Staff Report & SEPA DNS

Logan's Landing

Site Plan Review, Critical Area Permit & SEPA DNS

Land Use Application Nos.:	SPR 22-001 (Site Plan Review), CAP 22-001 (Critical Areas Permit), SEP 22-003 (SEPA Checklist) NOW WLD-2023-006
Applicant & Property Owner:	Belmont-Lewis Holdings, LLC Attn. Shayne Olsen PO Box 1940 Bend, Oregon 97709
Additional Representative:	Wyndham Enterprises, LLC Attn. Ed and Judy Greer 13023 NE Hwy 99, STE 7-126 Vancouver, WA 98686
Site Location:	Franklin Loop off of Belmont Loop in Woodland, WA 98674.
Parcel No. & Size:	50680023, 50729, and 50730. Parcel 50714 will also be impacted. Approximately 20 acres.
Zoning Designation:	Highway Commercial (C-2), Light Industrial (I-1)
Date Application Received:	January 27, 2022 (March 22, 2022 original fully complete date) Modified Application: August 14 th , 2023
Notice of Complete Application Issued:	Last submittal on August 22 nd , 2023
Notice of Application & Likely DNS issued:	NOA issued September 6, 2023

A Site Plan

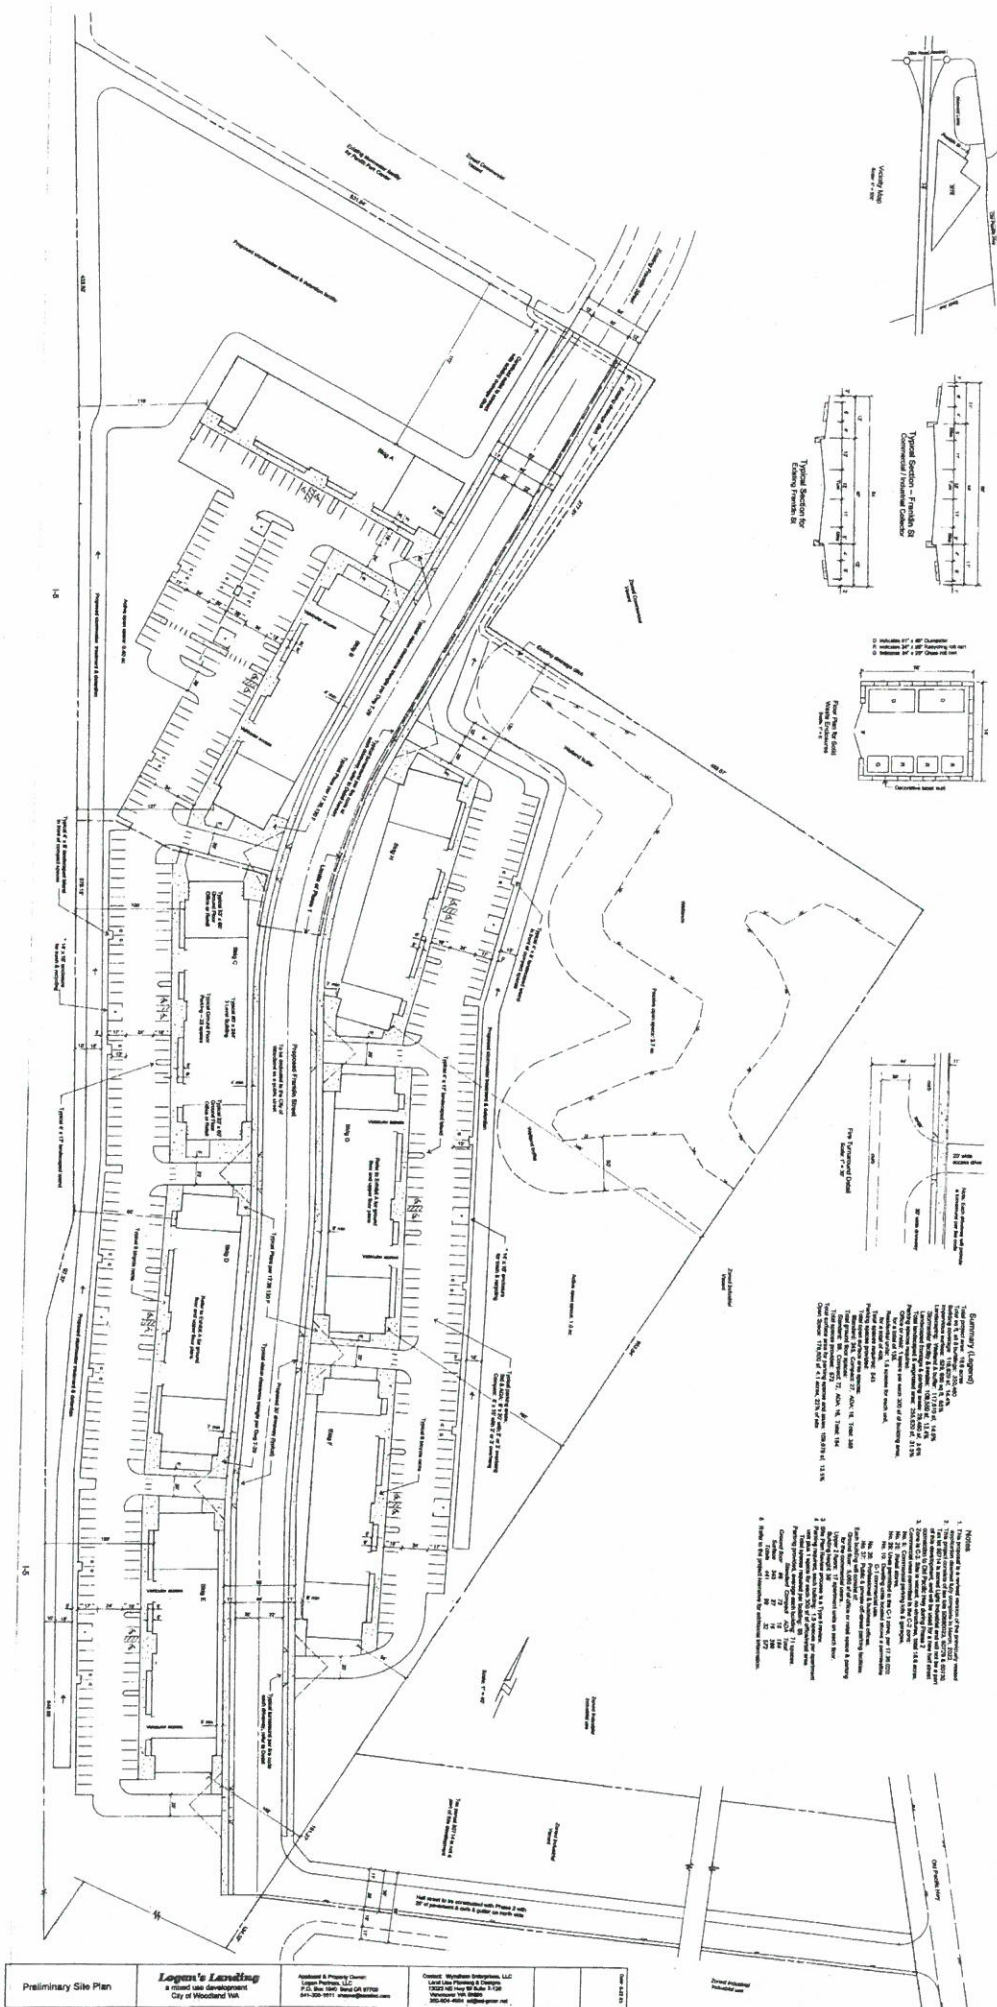
- The preliminary site plan indicates the discharge from the proposed stormwater treatment and detention facility is to an existing flow control facility. The stormwater runoff from the site must be discharged to a natural drainage way or discharged to the City's storm drain system, not a downstream flow control facility.

Finding 47: Site Screening and Buffers – Fencing and the use of walls are not shown on the site plan or landscaping plans. Any of these features which are added shall be placed in accordance with WMC 17.36.130 (N). (See Condition #32.g)

Finding 50: Lighting – Lighting is required to contribute to the character of the streetscape and not disturb adjacent development. The site plan notes that lighting will avoid conflicts and symbols for light poles are shown on the site plan, but there is no photometric or design information in the record. A full lighting plan will be required as part of the final engineering review process. (See Conditions #13, 30 and 32.j)

The proposal does not give a total space count, nor does the site plan include a complete parking analysis.

Finding 63: The provided site plan identifies proposed parking spaces but does not clearly identify dimensions. The preliminary site plan includes compact spaces which are not allowed in the commercial zone. In this case, flexibility in administration of the parking code should accommodate the use compact parking spaces. (See Condition #12.)

- a. This TIR must be submitted to the Department of Transportation and Consolidated Diking Improvement District #2 for concurrent review.
 12. A final site plan showing parking calculations shall be submitted with the final engineering plans. Said calculations shall consider the findings above and reflect the exclusion of parking that is internal to the buildings as discussed above. The site plan shall show the size and number of spaces, as well as the location, phase and/or building for which they are dedicated to. The use of up to 17% of compact spaces may be accepted for the final parking plan. The plan must show how ADA parking standards can be met by phase.

31. Applicant is responsible for submitting a revised site plan alongside proposed final civil engineering plan(s) at Civil Review. Civil review packet should include all documents required to document the applicant's compliance with listed conditions of approval, as well as all revised engineering plans reflecting provided engineering comments. The civil review application can be found: <https://www.ci.woodland.wa.us/planning/page/civil-review-submission>.

B
Landscape &
Lighting Plan

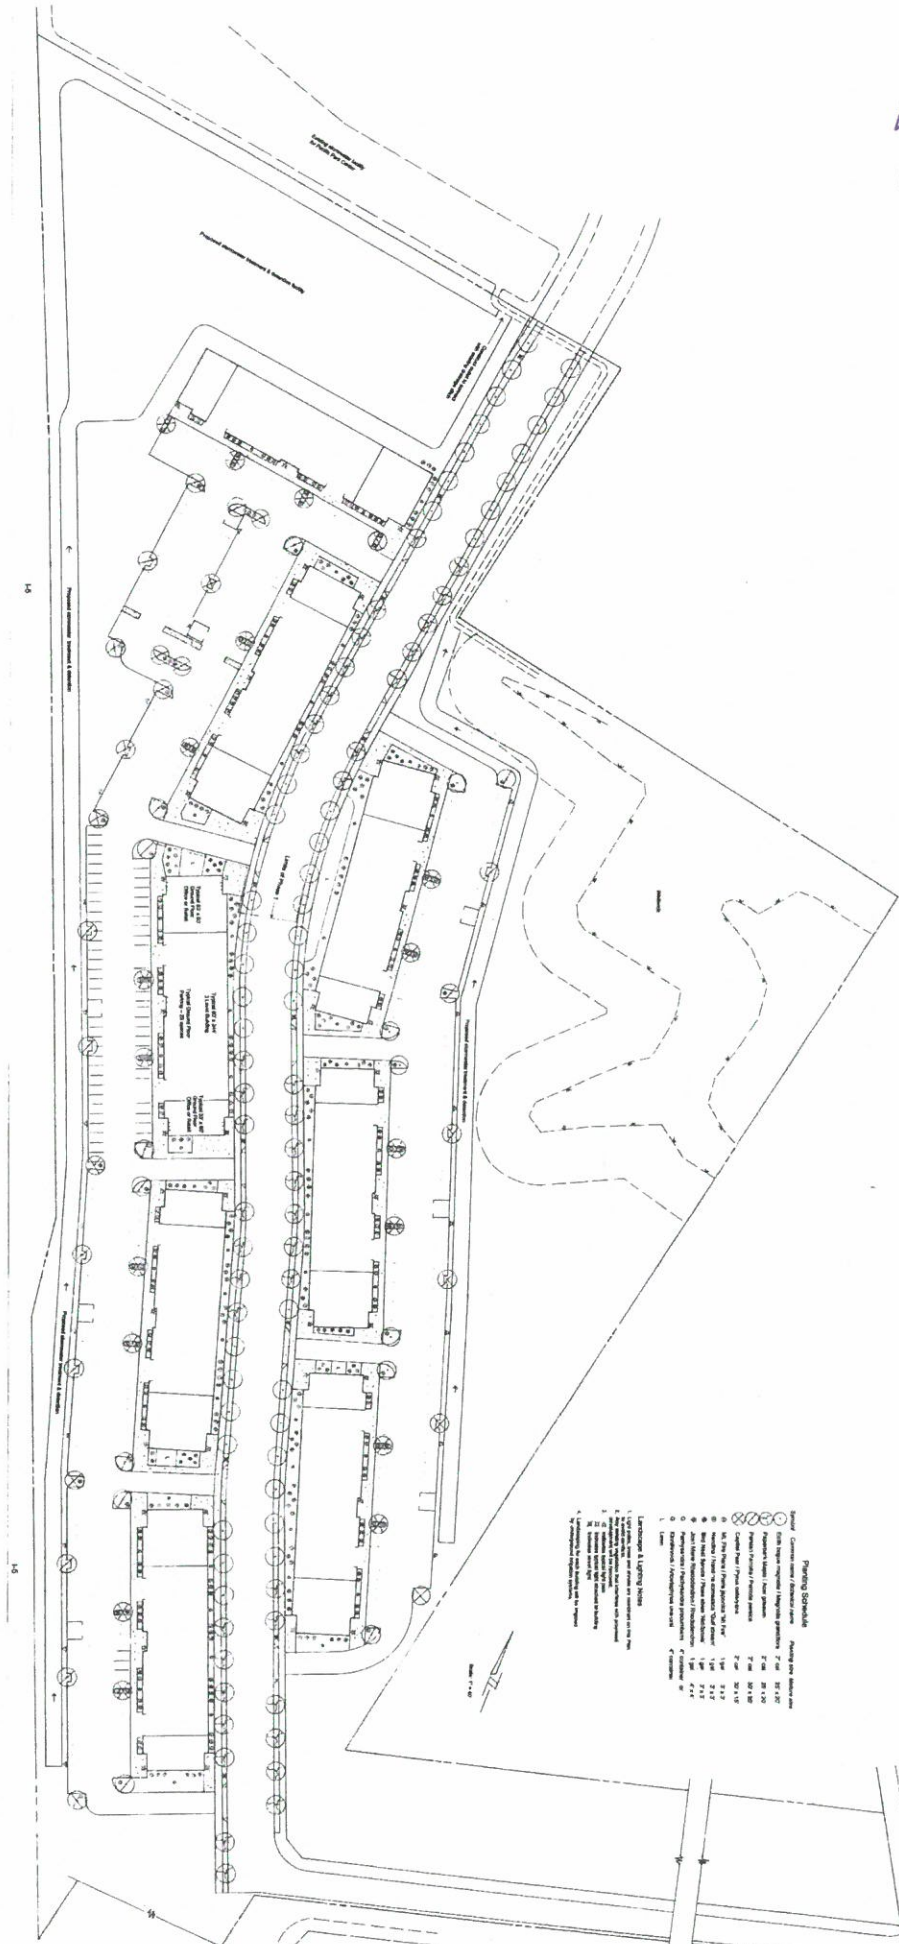
Finding 45: Site Screening and Buffers – Street frontage landscaping is required but clear vision triangles must be maintained at all entrances. The submittal package does include a landscaping plan but it is not stamped by a qualified professional and it is not of a scale to properly review the specifics of this standard. Therefore, conditions have been added that will ensure that the landscaping can meet the standards of WMC 17.36.130 (N) as part of the final engineering review process. (See Condition #32.g)

Finding 46: Site Screening and Buffers – Street frontage landscaping is required to screen parking areas. The submittal package does include a landscaping plan but does not have the detail necessary to properly review the specifics of this standard. Therefore, conditions have been added that will ensure that the landscaping can meet the standards of WMC 17.36.130 (N)(4) as part of the final engineering review process. (See Condition #32.g)

26. Provide a Final Landscaping plan prepared by a qualified landscape professional alongside civil engineering submittal that meets the following conditions:

- a. The final landscaping plan shall indicate that street trees will be provided along street frontages by the applicant and/or their designee.
 - b. All trees identified in the landscaping plan must identify their caliper size at the time of planting measured at four feet above grade.

- c. All street trees identified on the final landscaping plan must have a caliper measurement of at least two inches at the time of planting.
 - d. Add a note to the final landscaping plan that acknowledges that the property owner is responsible for maintaining on-site landscaping shall be permanently maintained in a neat and orderly condition per WMC 17.20.090 (B).

Logan' Landing
 Revised Ground Floor Plan

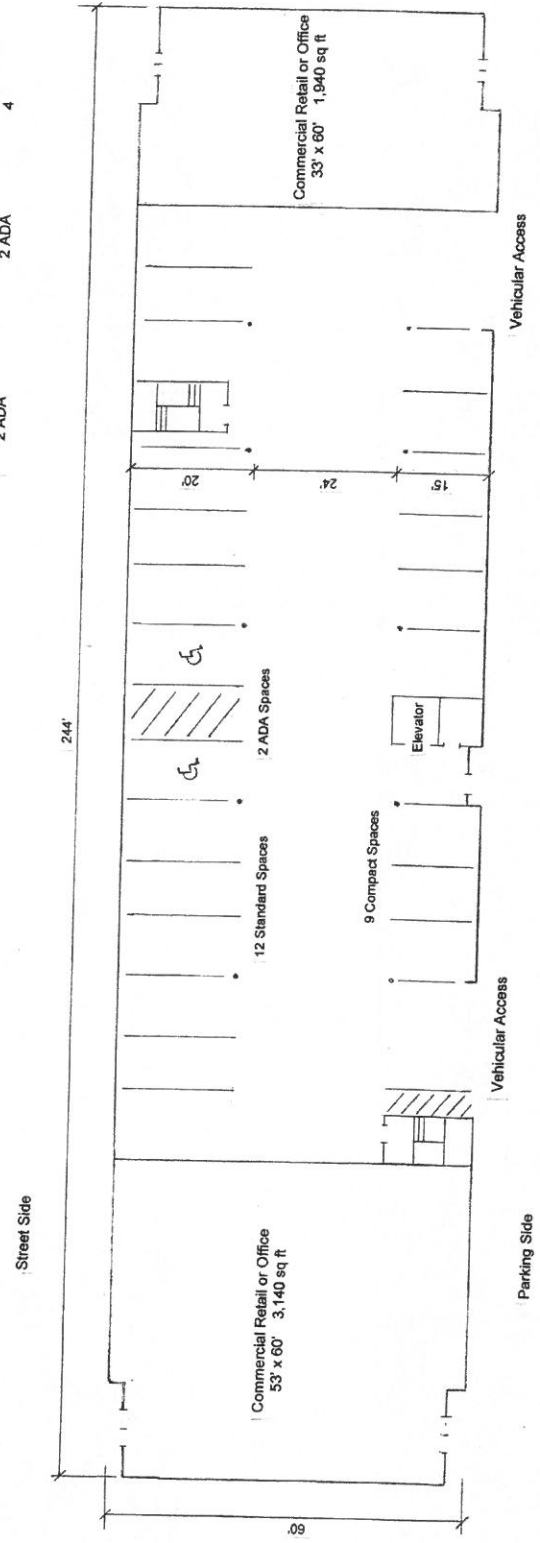
Finding 27: Based on the above analysis, the parking spaces within the building cannot be counted toward the required parking spaces for either the commercial or residential units. A condition of approval has been added requiring that the parking be recalculated without those spaces. (See Condition #12)

Finding 28: With the loss of commercial parking within the structure, the proposal can no longer claim that the units above the parking are compliant with subsection (10) above. The entire ground floor will need to be converted to commercial space for a commercial use permissible by zoning. This will further change the parking calculations for the site. A condition of approval has been added requiring that the parking be recalculated with a full ground floor of commercial space. (See Condition #12)

Finding 53: The revised ground floor plan shows a building footprint of approximately 244 feet by 60 feet for a gross foot print of 14,640 and a 3-story total building mass of

3 REAR ELEVATION

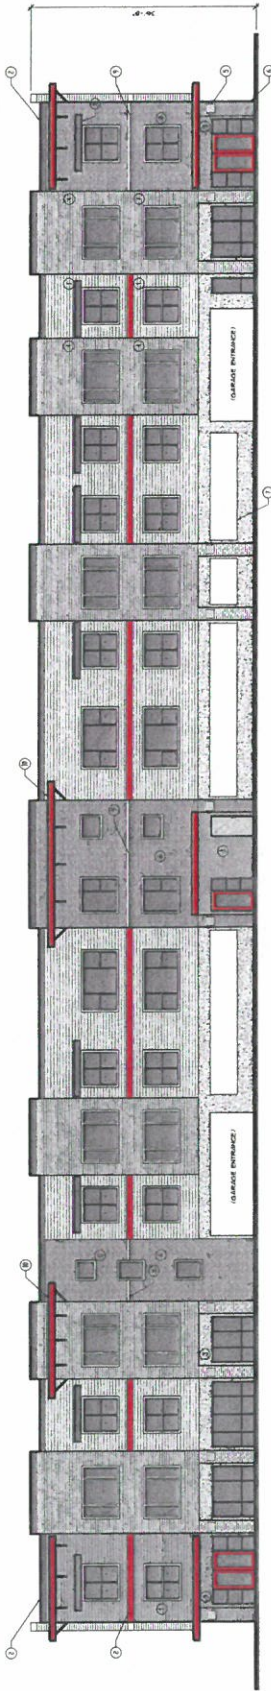
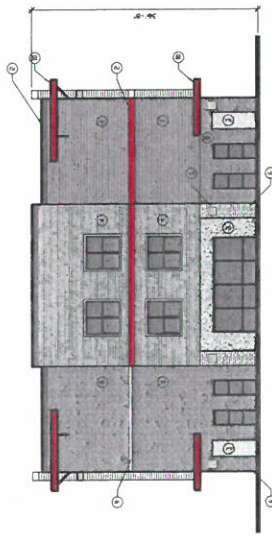
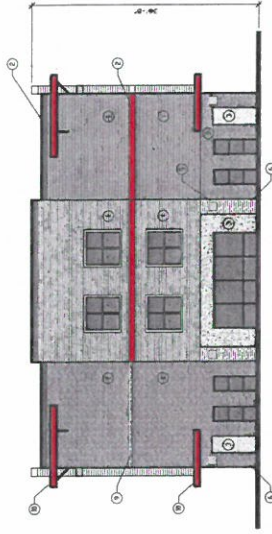
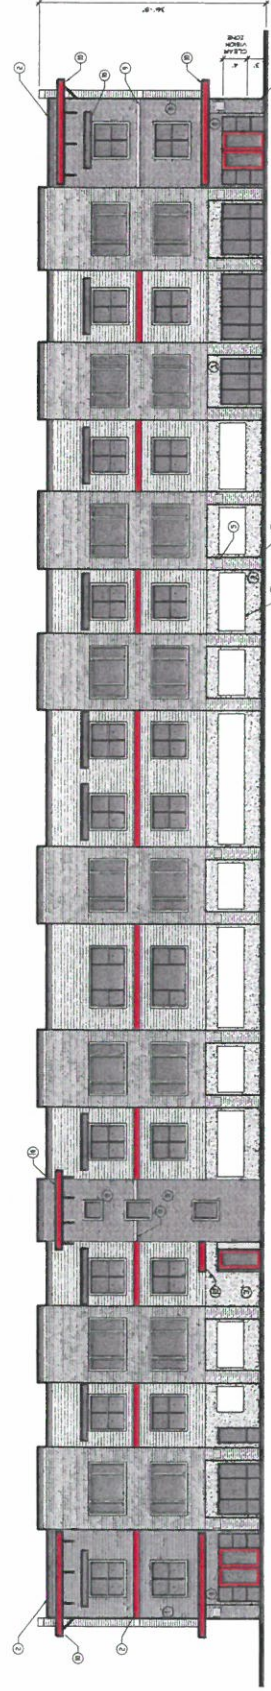
Finding 35: Preliminary elevation plans show a typical three-story structure with a proposed height of 36 feet and 8 inches. This meets this standard and has additional room in the event rooftop equipment needs screening. An advisory condition of approval regarding height has been added. (See Condition #13)

The building elevations provide marginally successful use of these standards but fall subject to the repetition of vertical and horizontal features that accentuate the mass of the building. Additionally, there is a repetitive use of building materials and a lack of canopies, plus window and door treatments that, when added, will reduce the mass of the structure. The elevations do not show any lighting features that can be used to help make the structure more pedestrian scale friendly.

Note: As discussed with staff, the plan does show architectural features that break up the mass and roofline, but the question was whether they are repetitive and whether they break up the mass. This will be reviewed again with the final site plan and during the appeal if there is one. One contention is whether the front of the building faces the street or the parking lot since the commercial entrance features would be on the parking lot side of the structure. Staff opined that effective entrance treatments like those shown in code would face the parking lot and would meet the intent of the code for massing, even if the side of the building facing the street may not be affected by those treatments.

Finding 41: Rooftop Equipment Screening – The proposed building elevations show no rooftop equipment and there does not appear to be ground mounted equipment on the site plan, therefore staff assumes that the buildings show screening for this equipment. An advisory condition for this has been added in the event that building is modified during the final design process. (See Condition #13)

- a. Building elevations and site plan details showing and how each building will meet the "building prominence" section (E).
 - b. Building elevations and site plan details showing and how each building will meet the "building entrance" section (G).

- c. Building elevations and site plan details showing and how each building will meet the "Articulation and Massing" section (H).
 - d. Building elevations and site plan details showing and how each building will meet the "sidewalks and street trees" section (J)
